CROWN CEMETERY DEVELOPMENT APPLICATION - VARROVILLE

Response to IPC queries

RESPONSE TO SUBMISSIONS

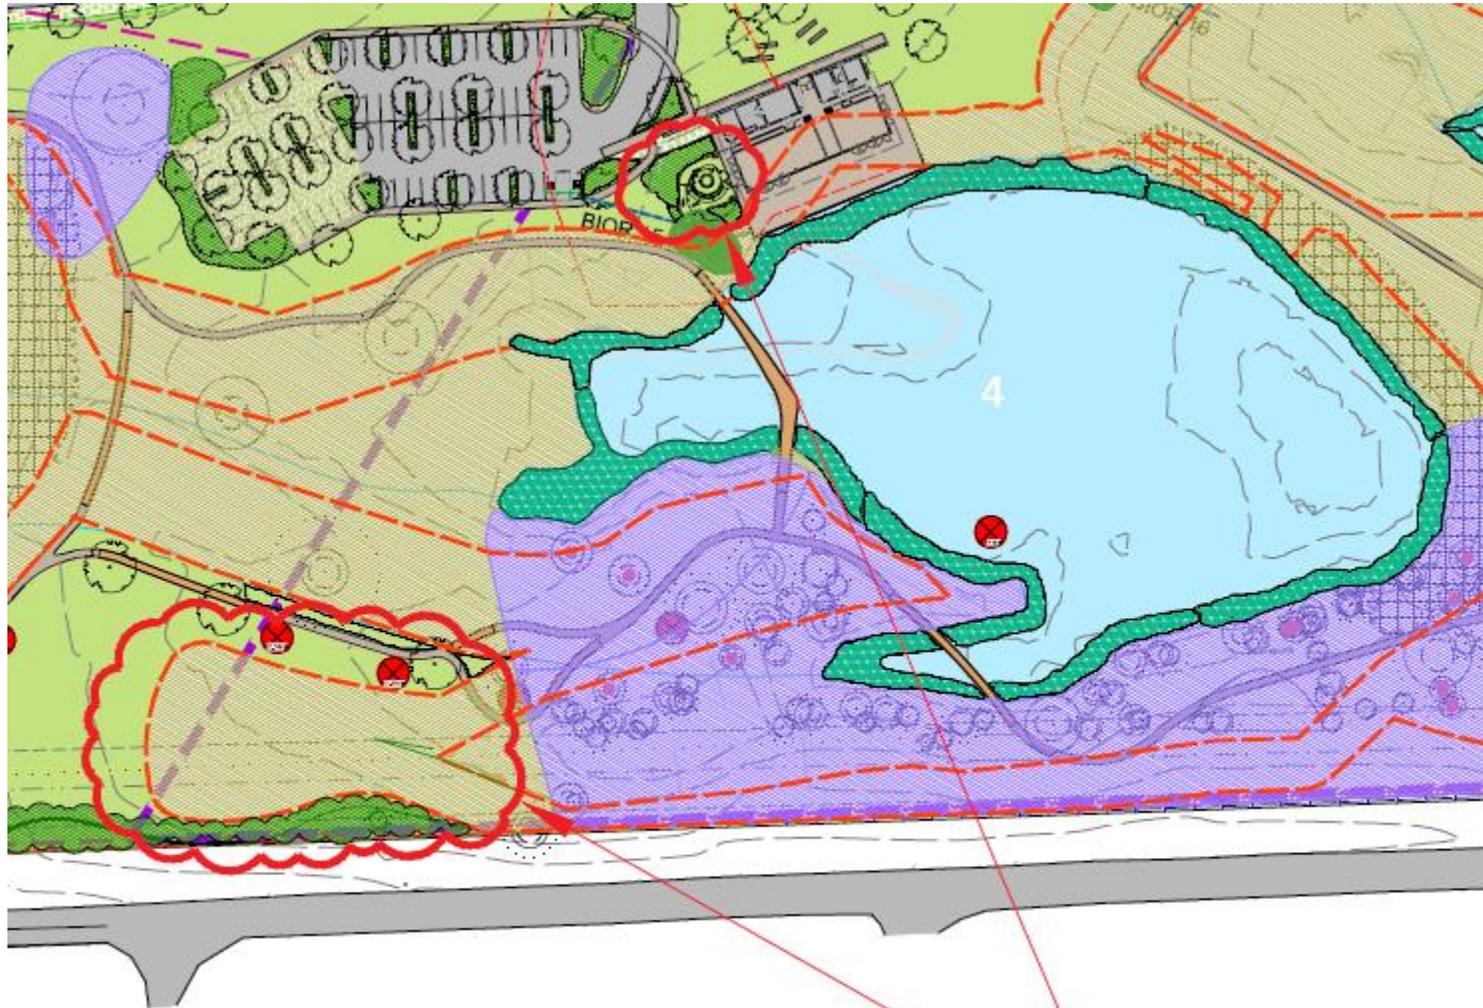
- Impacted CPW - colour change
- Path removal on escarpment

REV A

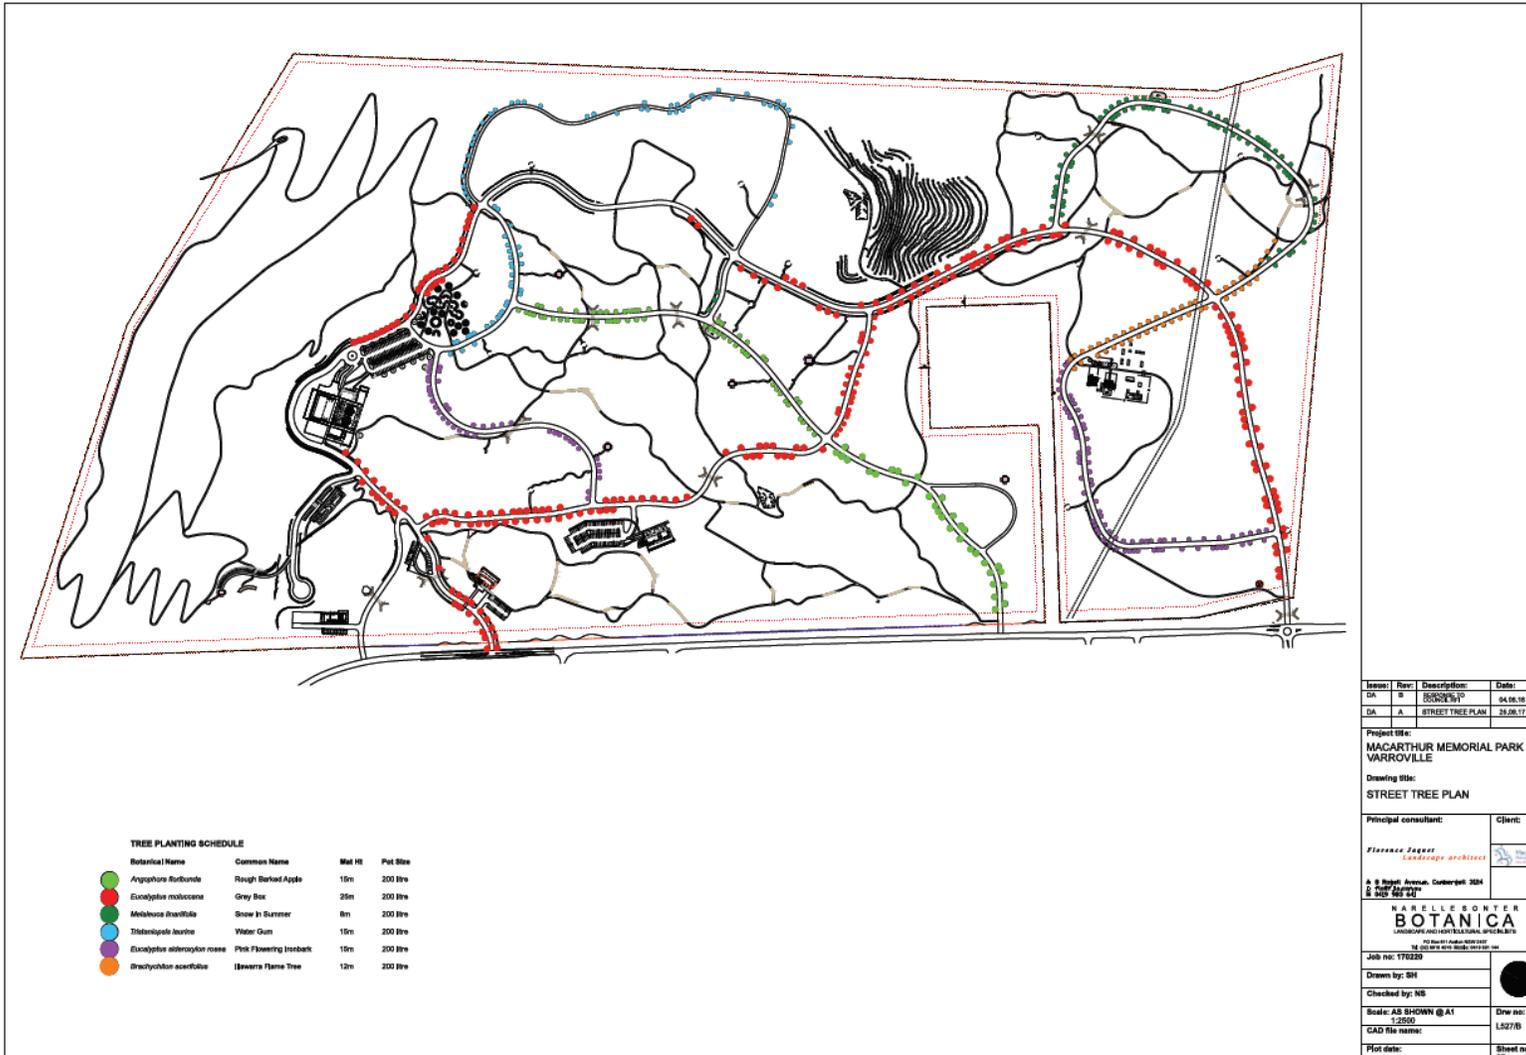
- Impacted CPW - colour change
- Café Playground – additional fencing note
- Main site entry realignment

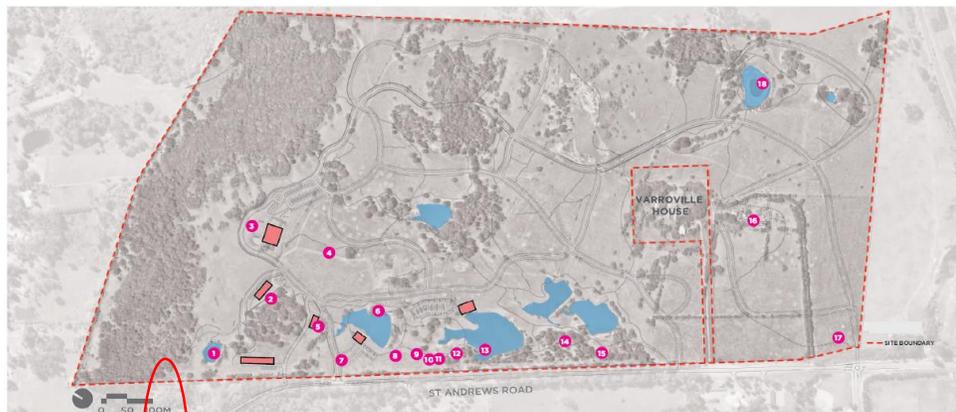
- Adjustment to Analysis map in Landscape Design Response report in relation to Picton soils

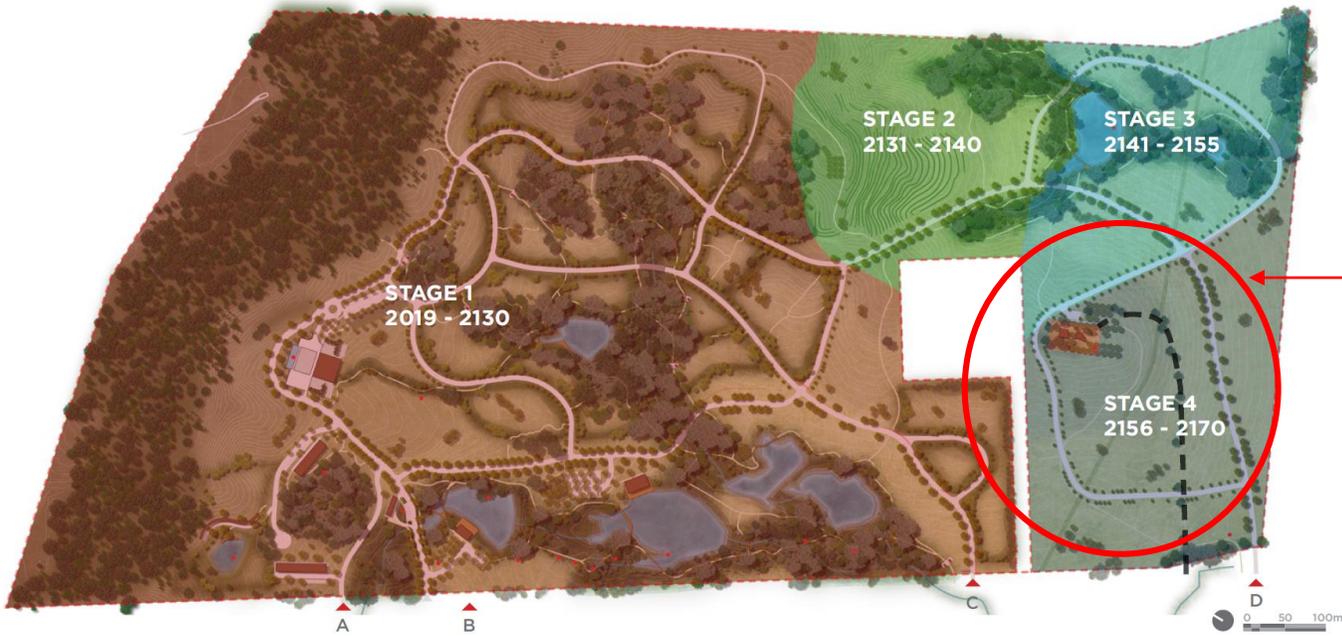
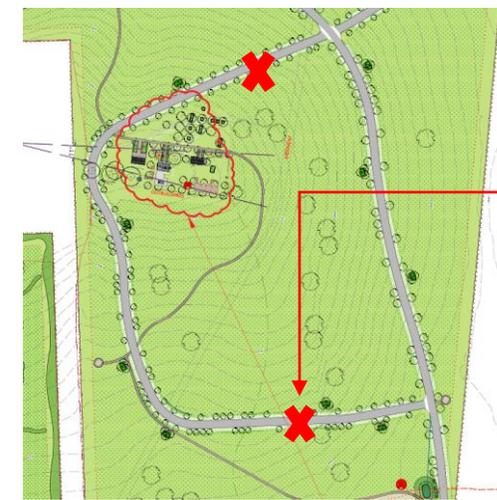
Q 7: The loop road in Stage 3 and 4 appears to provide the only access to the outbuildings precinct? When does the applicant plan to repair/restore the outbuildings and put them to re-use?

- The proposal relies on part of Road #11 (loop road) to access both graves and outbuildings in Stage 3 and the rest of the loop road to access the graves in Stage 4.
- Multiple options were explored away from Varroville House but rejected due to visual and physical impact due to steep topography. Dead-end options were found unacceptable to RFS (Refer Original Masterplan).
- With the imposition of the removal of Road #11 as part of the condition of consent drafted by DPE, to respond to Heritage Council's concerns, long term access to both outbuildings and burial areas is unresolved.

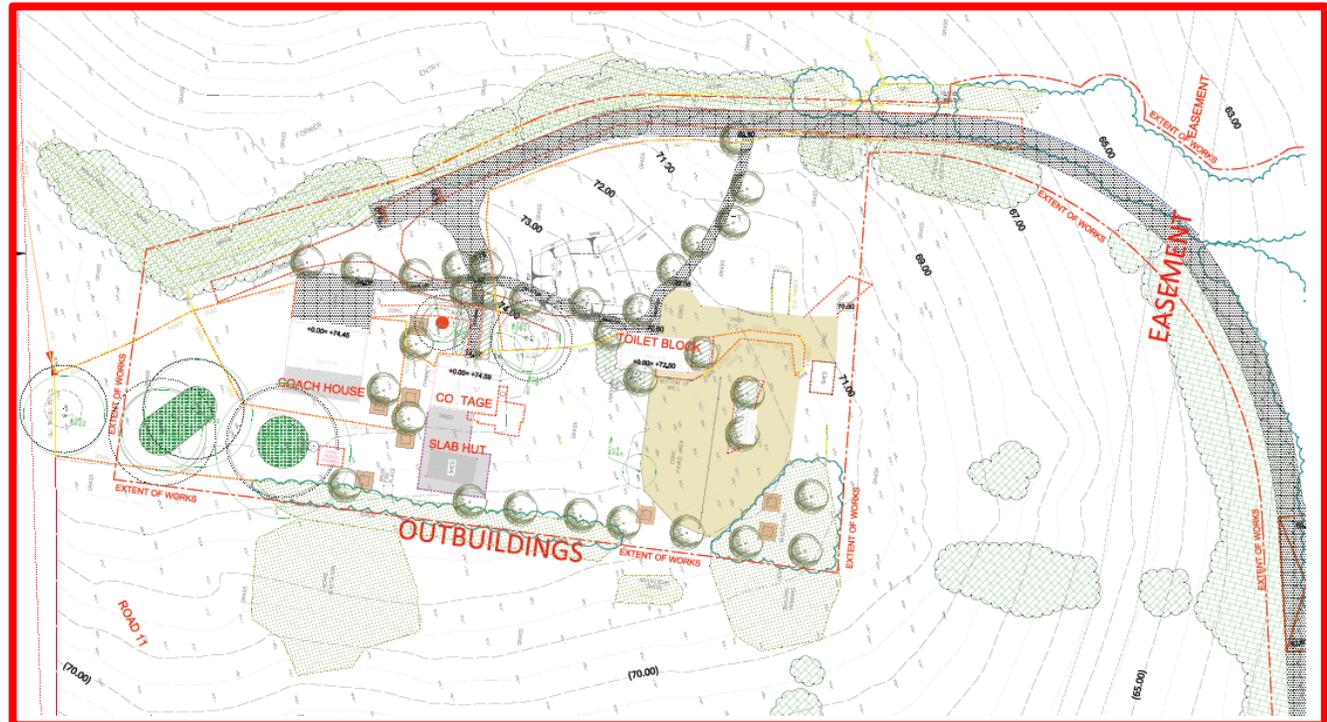
Q 7: The loop road in Stage 3 and 4 appears to provide the only access to the outbuildings precinct? When does the applicant plan to repair/restore the outbuildings and put them to re-use?

The Outbuildings are proposed to be restored and put to re-use as part of Stage 1 (Refer DA's Stage plan).

- Widened from a 2.5m driveway to a 4.5m driveway with passing bays.
- Existing vegetation (ie African Olives and Coral trees) to be removed on south side to allow for widening but retained on north side to provide a visual screen from Varroville House and shade for pedestrians.

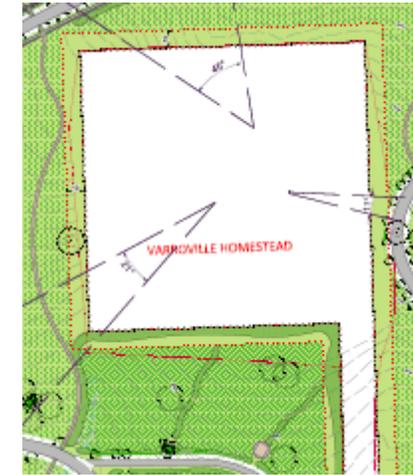
Q9: How was the 10 metre setback decided?

The buffer zone was self-imposed as Campbelltown City Council’s DEP does not specify, and by default is 0m.

Figure 33. Site Analysis of Original Driveway

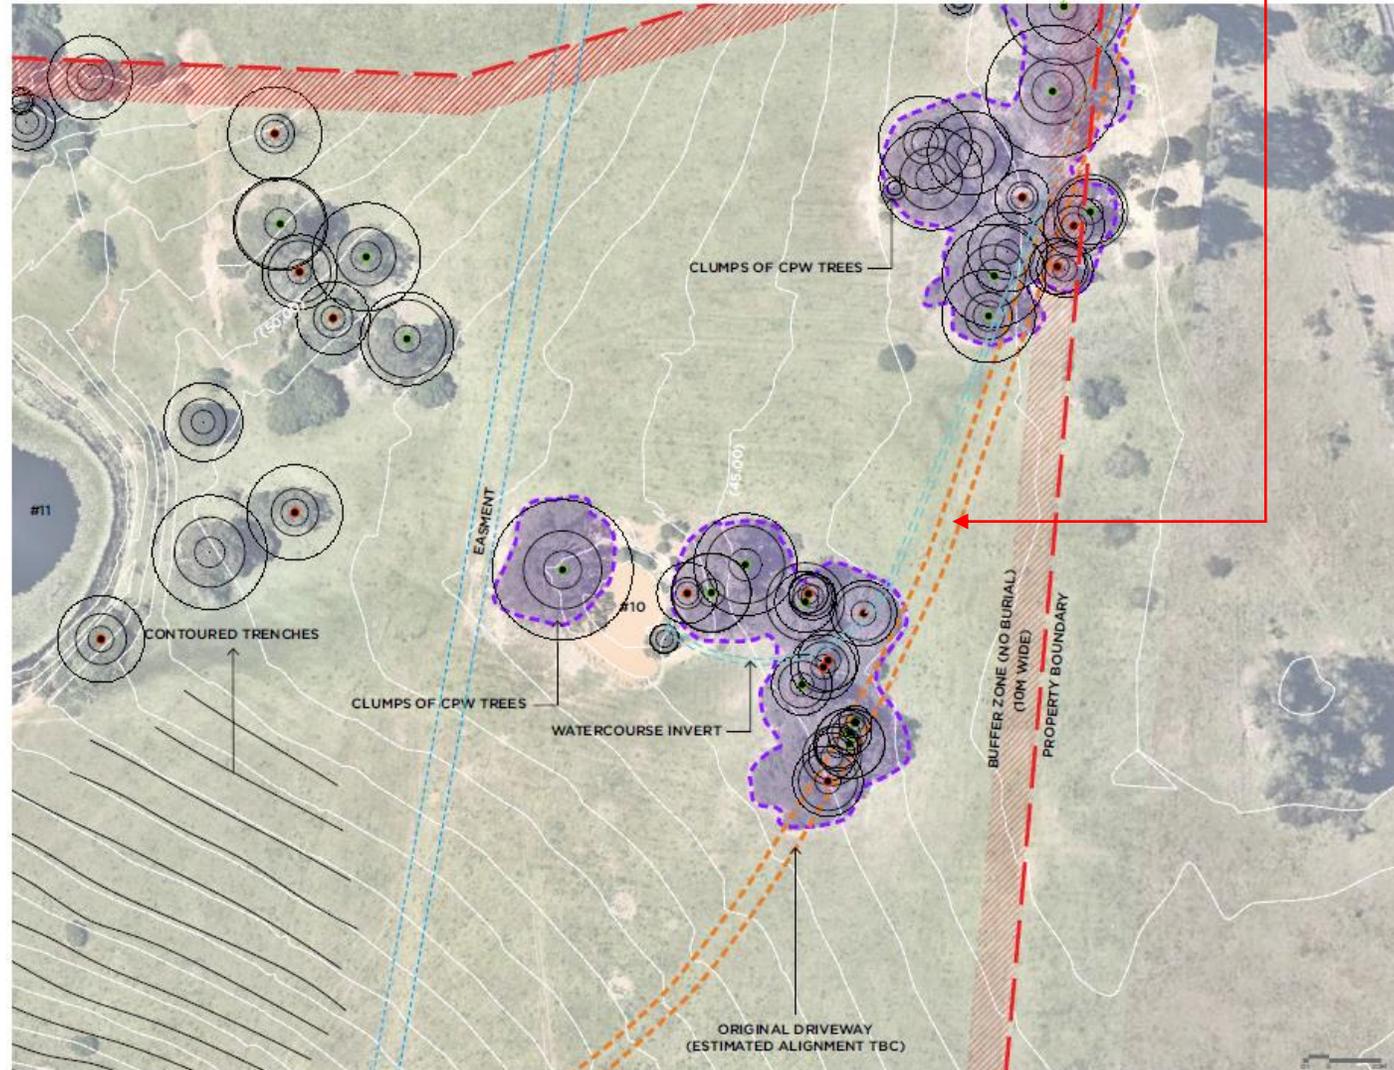
Q 10: Show us the former carriage drive?

It is evident from early aerial photos that its alignment changed and was duplicated in places.

Further archaeological investigations are required to establish its exact alignment, the material used and the pattern of tree planting which may (or may not) have lined it.

Figure 35. Detail Plan of Outbuilding Precinct

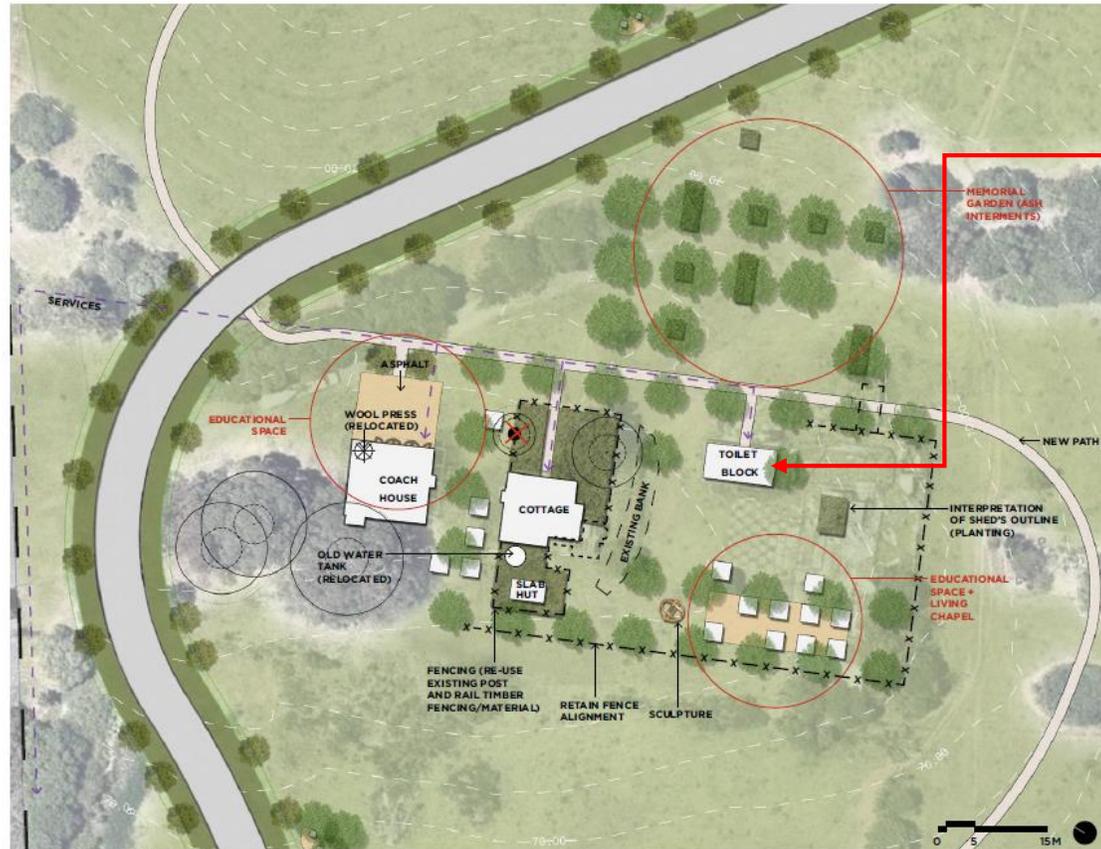
Q11 (continued) : Part 2: Provide an explanation of the interpretation of the outbuildings.

- The slab hut that will be retained, fenced off and managed as a relic.
- The sheds will be removed. The Shed's location will be interpreted with low planting or paving patterns.

- The lay of land is to remain unchanged and predominantly grassed.
- The outbuildings will remain visible from the west and south through filtered views through low tree planting. (as is currently the case).

- The tree grid is extended eastwards where the design progressively transforms into a memorial garden.
- Remnant fencing will be re-used generally in its current alignment to define the outbuilding precinct and separate it from the burial sections.

- A path is provided from St Andrews Rd to facilitate access by the school/students.
- Localised grading will be used to minimise the visual impact of the proposed road when viewed from Varroville House.

Typical lawn burial – concealed beams

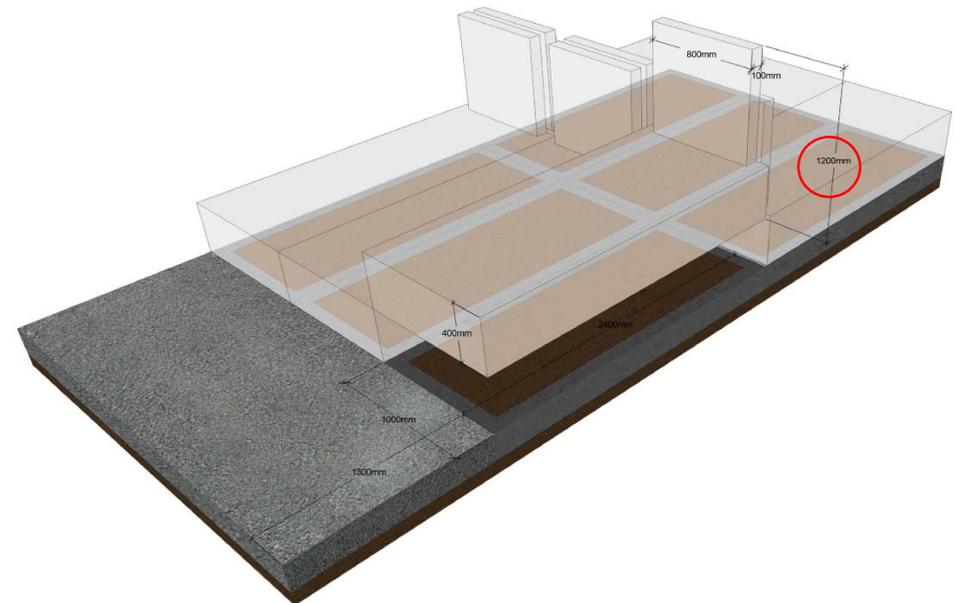
Q 22: How has the landscape design responded to minimalising the visual impacts of the proposal?

- Buildings are kept to a minimum, six in total and represent less than 0.5% of the total surface area.
- As the Visual Impact of a cemetery generally relates to headstones, the design provides “low visual impact” plaque in lawn near roads and hides headstone into screened “burial rooms”.
- Headstones are limited in height (Maximum 1.2m high)(refer Management Plan and FJLA drawing L604)

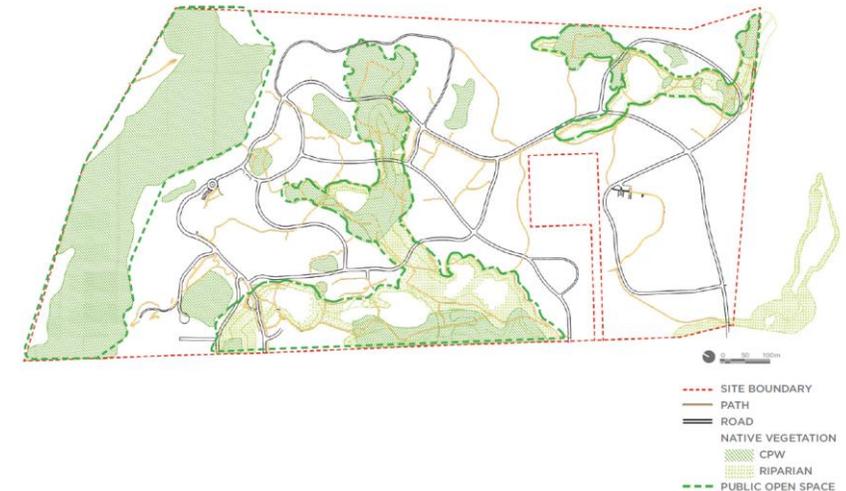
Hard surfaces amount to 50,000m2

Response: 50,000m2 represents 4.4% of the total area, which is not significant

Figure 3 – Extract of current aerial showing clear evidence of similar trenching across the adjacent Mount Carmel Retreat Centre with zoomed in extracts provided below

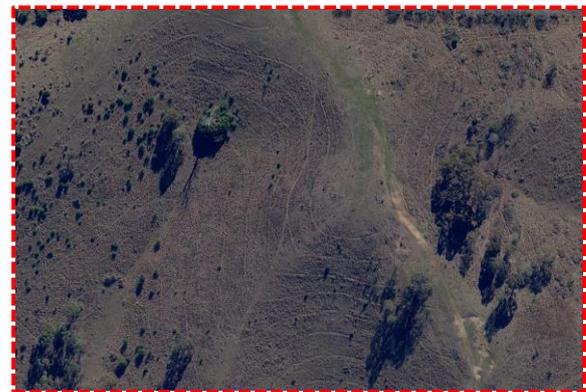
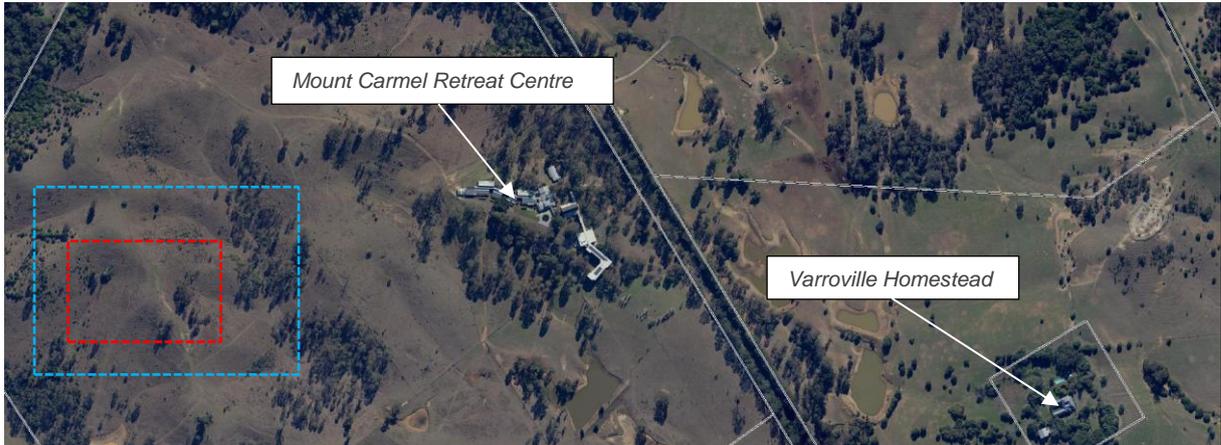
2. Mr. Quint claimed that the proposed cemetery use would have a detrimental impact on the significant remnant vineyard ‘trenching’, notwithstanding that the proposed cemetery landscape masterplan seeks to retain a significant portion of and interpret this element of the site. We do not dispute the significance of the remnant vineyard trenching, which at one point extended across a large portion of the subject site as well as the adjoining Varroville Homestead lot, and neighbouring properties (refer below to Figure 3). Evidence of this vineyard trenching within the boundaries of the Varroville Homestead lot has largely been lost due to substantial landscaping works.

A significant area of the remnant former vineyard trenching has been included for retention and interpretation as part of the landscape masterplan. Further, the interpretation strategy will communicate the known extent of the trenching. As stated above, the landscape masterplan was specifically amended to maximise retention of the most intact areas of remnant trenching. Whilst we have acknowledged the significance of the remnant trenching, we do not consider that this should preclude development in all areas which have evidence of remnant trenching, and that it is more than appropriate for a large representative area to be retained, including the most intact sections.
